TODD ACRES SUBDIVISION, SIXTH UNIT,
REVISED LOT 3 OF THE RESUBDIVISION LOTS
5&6

APPLICATION NUMBER 18 DATE February 7, 2013

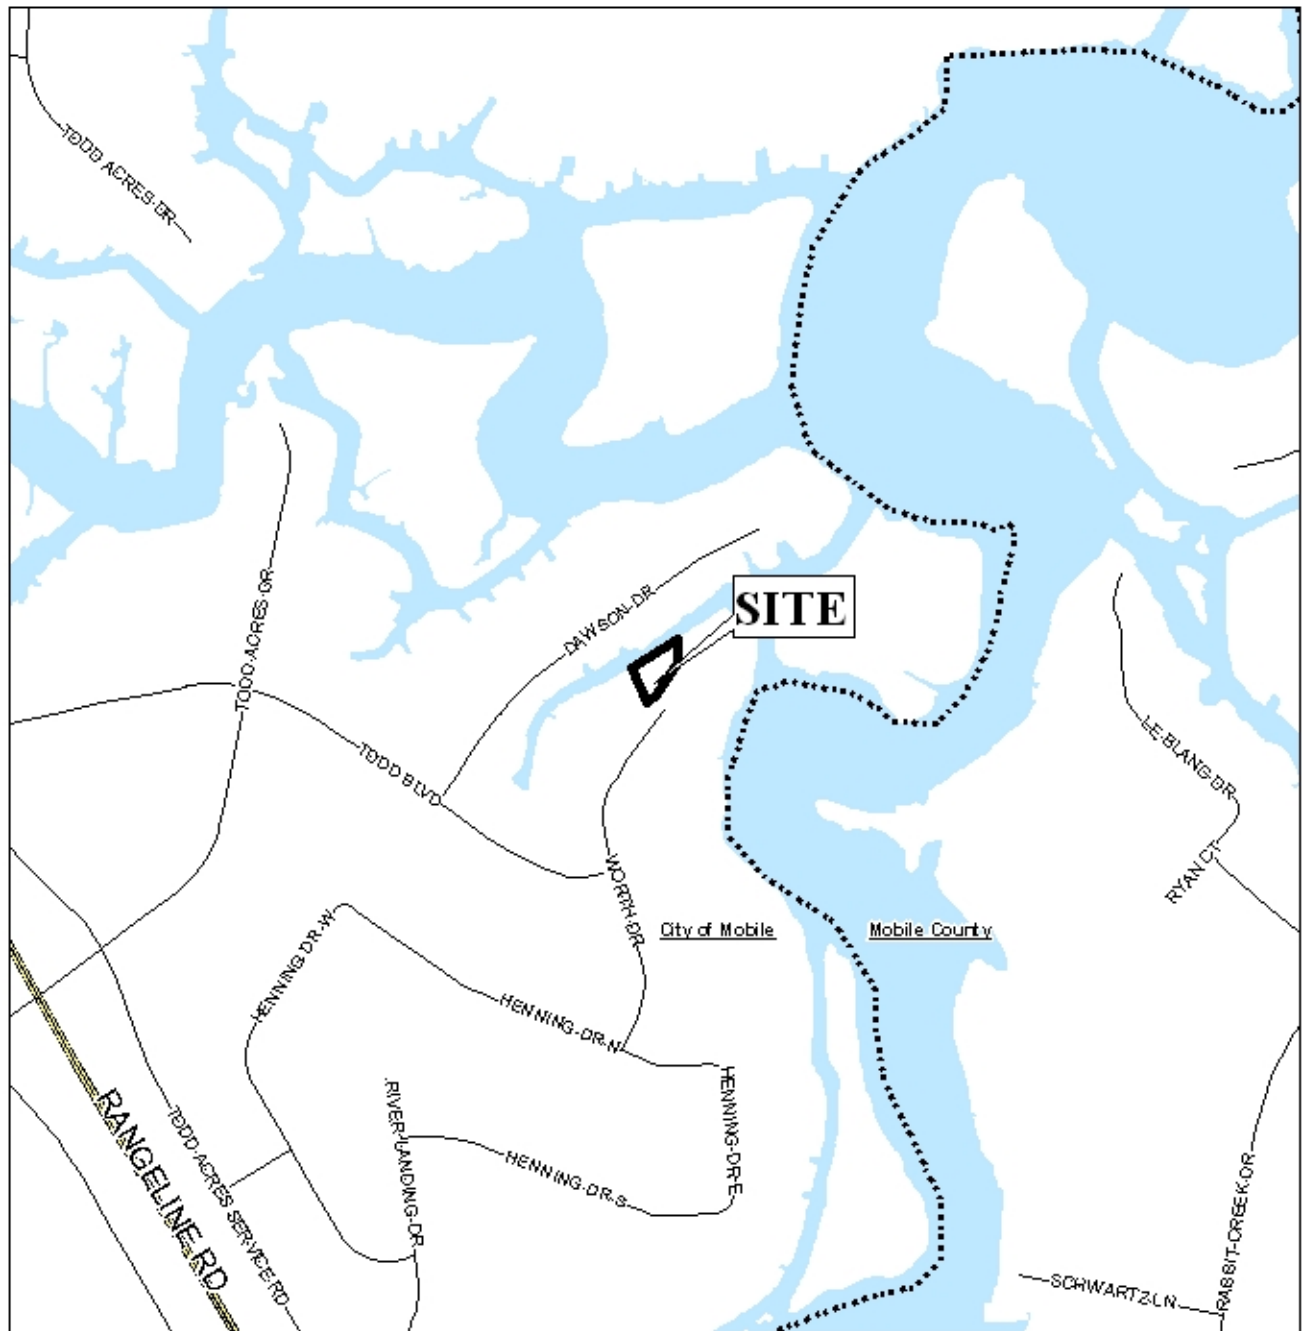
The plat illustrates the proposed 0.25± acre, 1 Lot subdivision, which is located at the North terminus of Worth Drive, in City Council District 4. The applicant states that the site is served by public water and sewer.

The site was part of a three lot subdivision approved by the Planning Commission at its July 10, 2008 meeting. The purpose of this application is to reduce the front setback line from 30 feet to 25 feet. Section V.D.2. requires the minimum building setback line to be located where the lot is 60 feet in width. The applicant is requesting a waiver of this requirement in order to allow a larger building area away from the adjacent canal. Due to the unusual shape of the lot and its water front condition, it is recommended that the Planning Commission consider approval of the request.

The proposed lot fronts a cul de sac at the North terminus of Worth Drive with 100' of right-of-way. Section V.B.14. of the Subdivision Regulations, now requires cul de sac rights-of-way to be a minimum 120' to accommodate the 2003 International Fire Code. Since the cul de sac was in existence before the amendment and only a portion is being re-subdivided, it would be impractical to enforce this requirement at this time.

The plat meets the minimum size requirement for developments with access to public water and sewer. The 25-foot minimum building setback line is depicted on the preliminary plat. If approved this information should be retained on the Final Plat.

Based upon the preceding, and with waiver of Section V.D.2., of the Subdivision Regulations and is recommended for Tentative Approval, subject to the following conditions:

- 1) placement of a note on the final plat stating the lot is limited to one curb cut, with the size, location, and design to be approved by Traffic Engineering and conform to AASHTO standards;

- 2) labeling of each lot with its size in square feet, or the provision of a table on the final plat with the same information;
- 3) the approval of all applicable federal, state and local environmental agencies prior to the issuance of any permits or land disturbance activities;
